## FIELD OBSERVATION REPORT

Central Hardin High School – Phase 2, 2019111 -CA8

Report No: 24

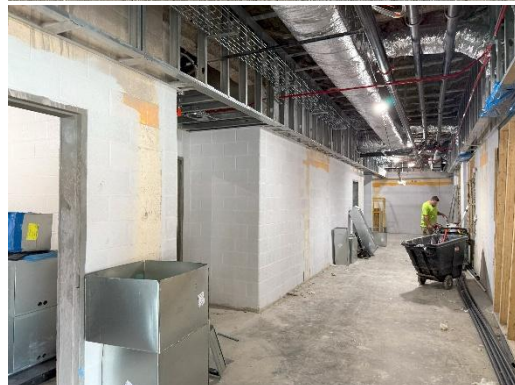
- l) The floor condition under the overhead door needs to be addressed. The rubber floor tile needs to be covered with an aluminum threshold under the door.
